**Bridge Road and Victoria Street Activity Centres
Draft Amendment C291yara**

Yarra Activity Centres Standing Advisory Committee Report 3

24 June 2022

Plan 1: Height and Interface Plan – Precinct 5 Victoria Street East End

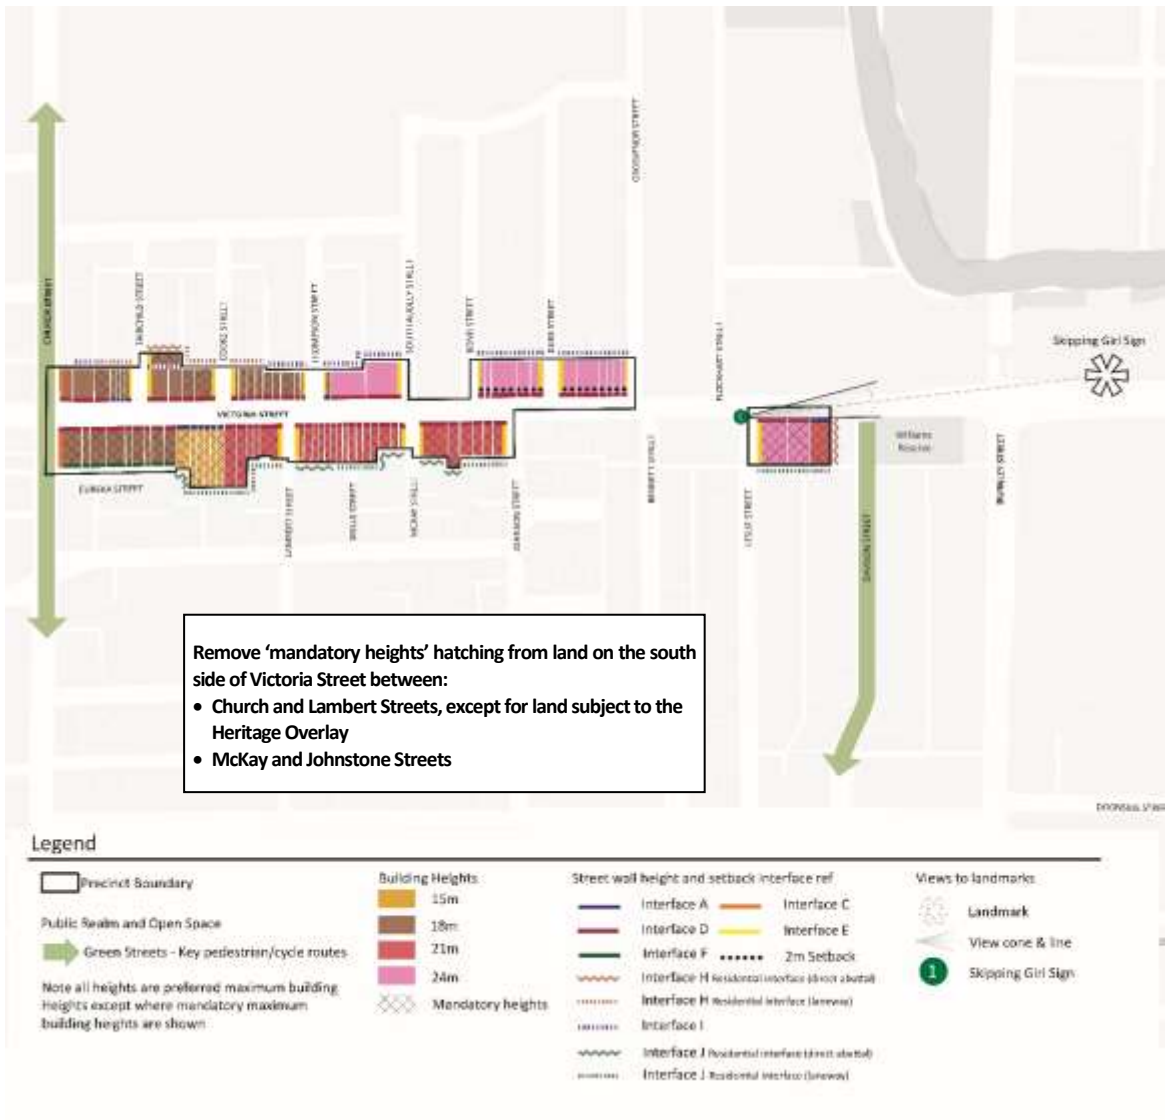
Delete Plan 1 (Height and interface plan) and replace with below
